Subject: Oconee Nuclear Station  
Docket Numbers 50-269, -270, -287  
UFSAR Chapter 15 Transient Analysis Methodology,  
Topical Report DPC-NE-3005-P, Revision 1

Responses to Request For Additional Information  
DPC-NE-3005P Revision 1

Figure 12

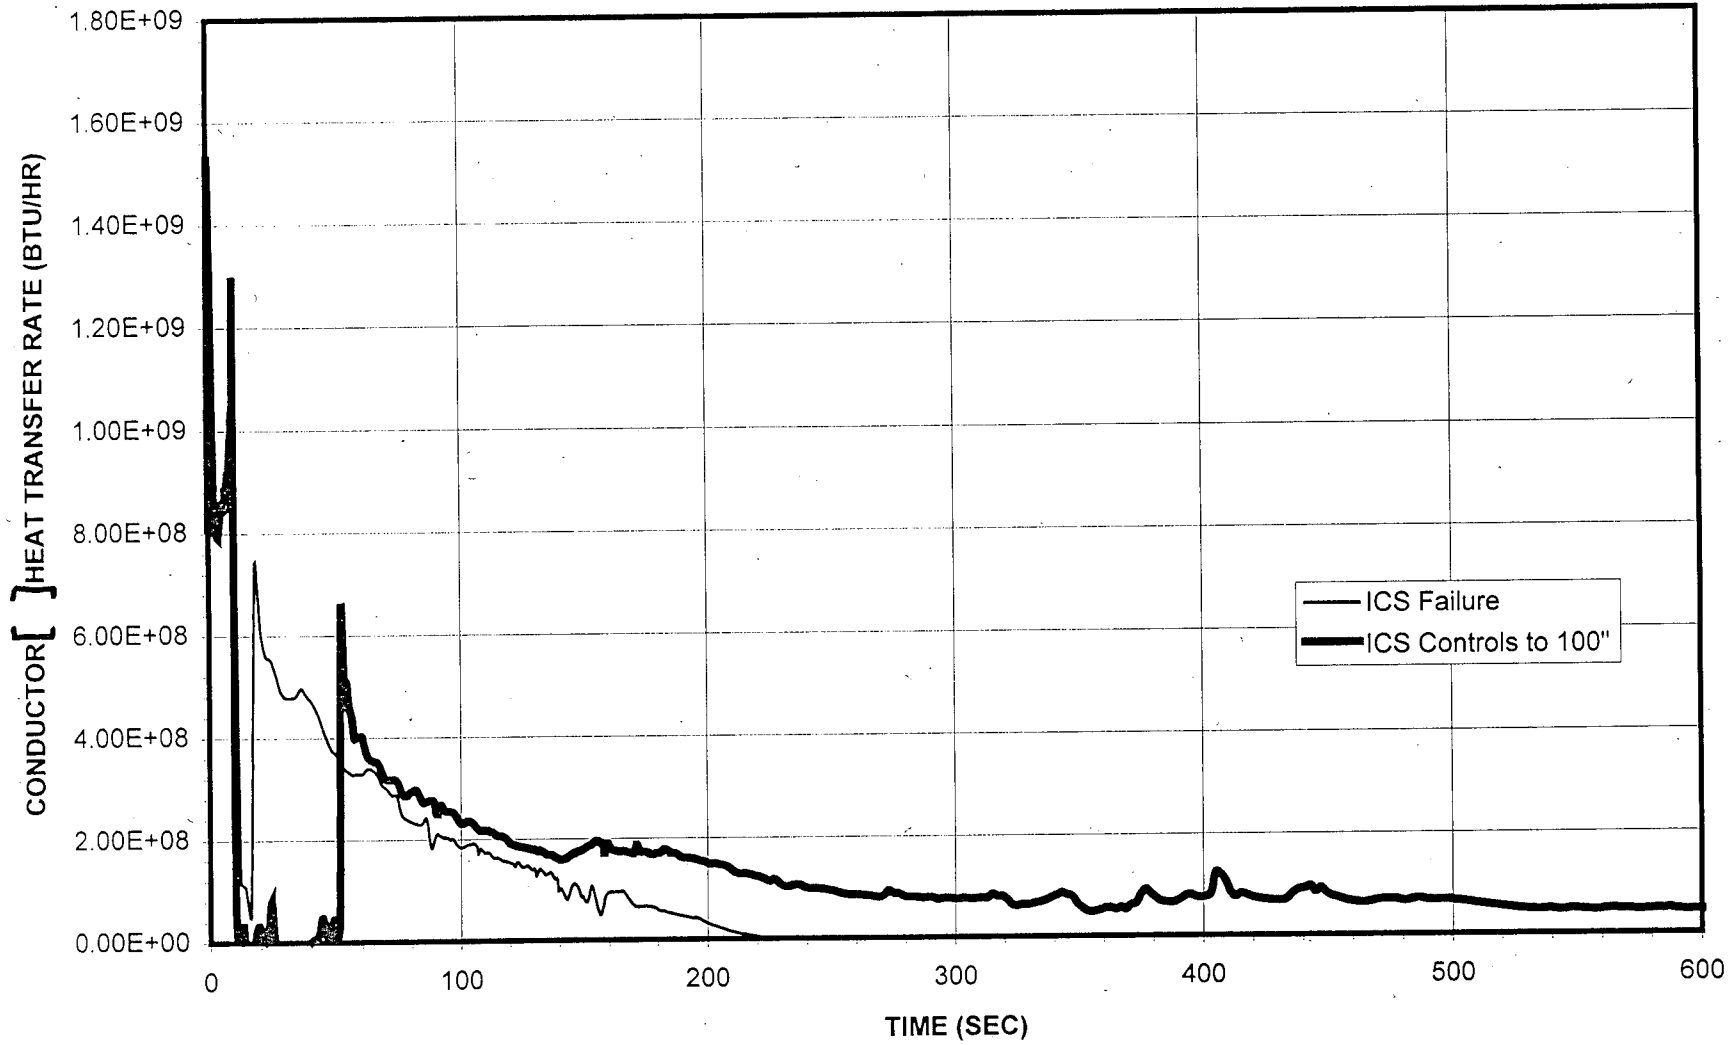
- Q6. Page 15-14 states that the limiting assumption with respect to maximizing overcooling and reactivity addition has been determined by analysis to be the case when the Integrated Control System (ICS) is controlling main feedwater. This case was found to cause more overcooling than the case that assumes failure of the ICS, which would permit unlimited main feedwater addition to the affected steam generator. Provide comparisons of the conditions within the affected steam generator secondary that would cause the ICS operating case to be the worst case. Compare steam generator level, pressure, temperature, and heat transfer coefficients that are calculated by the RETRAN code.

Figures 7-16 show the heat transfer coefficient and the heat transfer rate for [ ] steam generator tube conductors. The [ ] were selected to show the axial variation in the predictions. The elevation and height of each conductor above the lower tubesheet are as follows:

Under full power steady-state conditions, the SG tube bundle heat conductors exhibit well defined heat transfer modes. The lower bundle region (Conductors [ ]) contains a relatively large amount of liquid, and is in the nucleate boiling heat transfer mode. The middle bundle region (Conductors [ ]) contains a larger ratio of steam to liquid, and is in the forced convection vaporization heat transfer mode. The upper bundle region (Conductors [ ]) contains steam and is in the forced convection to superheated vapor heat transfer mode. During the blowdown phase of the MSLB, conditions within the SG undergo a violent change. The decompression of the steam generator causes liquid in the lower region of the tube bundle and in the downcomer to be transported to higher elevations within the tube bundle by entrainment in the high velocity steam flow. Due to the severe pressure reduction, flashing occurs in the downcomer and results in reverse flow through the aspirator port. The reverse aspirator port flow contributes to a second boiling region in the upper tube bundle. Upper tube bundle conductors, which are at the hottest temperatures, are

periodically quenched with slugs of entrained liquid. For the ICS failure case, the SG gradually fills with liquid after the initial blowdown and experiences less boiling. The accumulation of subcooled liquid as the overfill progresses results in RETRAN predicting the forced convection to subcooled liquid heat transfer mode. For the ICS controlling to 100 inches case, MFW flow is unstable as the ICS attempts to maintain the level setpoint. During periods of high MFW flowrates the liquid levels within the tube bundle increase, causing heat transfer behavior similar to the initial blowdown. During periods of low MFW flowrates, the hotter tube bundle regions dry out. As the temperature differences between the primary and secondary decrease as the analysis progresses, heat transfer coefficients and rates decrease for all conductors for both cases. The integral effect of the heat transfer predicted for each tube bundle conductor is described in the preceding paragraphs. The overall heat transfer rate, and therefore the consequences of the two MSLB cases are quite similar, with the case with ICS controlling to the level setpoint slightly more limiting.
